CITY OF PORTLAND, MAINE

Project Name:	Parris Terraces	Project ID:	2017-287 and 2017-297 (IZ)
Address:	60 Parris Street	CBLs:	33-A-13
Applicant:	City of Portland		
Planner:	Nell Donaldson

PLANNING BOARD REPORT PORTLAND, MAINE

Parris Terraces, 60 Parris Street
Level III Subdivision and Conditional Use Review
2017-287
Horton LLC

Figure 4: Proposed driveway

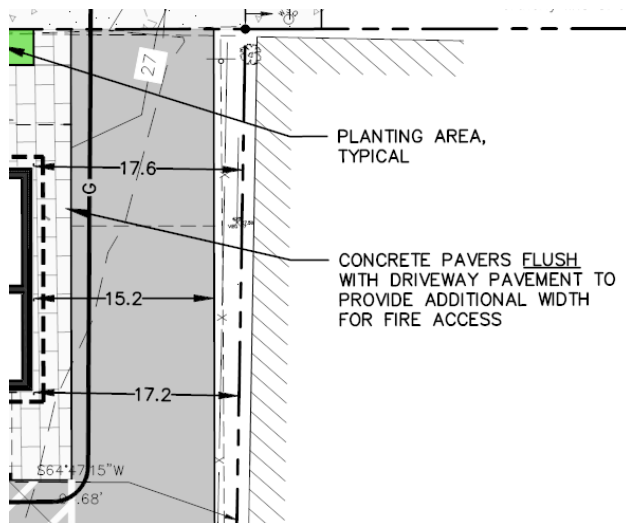
In response to staff comments, the applicant has increased the driveway width at the southern end of the site to 15.2'. The northerly edge of this driveway is proposed with flush concrete pavers as a means of differentiating a pedestrian way along the edge of the building.

As a driveway with two-way access of less than 20 feet in width, a waiver is required. Fire has reviewed the plan and indicated that they are satisfied with the driveway layout (*Attachment 4*).

The plans have been revised to provide a 15.2 foot wide driveway entrance that will function as a shared driveway (pedestrian facility will be flush). As noted previously, the project site would be expected to generate very low traffic volumes and during peak time periods traffic will primarily either be entering the site (returning home) or exiting the site (leaving home). During the morning peak hour, approximately 8 vehicles would be expected to exit the site and 2 vehicles will enter the site. This corresponds to one vehicle every 6 minutes. During the afternoon peak hour, about 8 vehicles would be expected to enter the site and 4 vehicles exit. This corresponds to one vehicle every 5 minutes. Given vehicle movement infrequency, the likelihood that trip levels will be less given the urban location, and low traffic volumes on Parris Street, I support a waiver from the minimum driveway width standard of 20 feet.
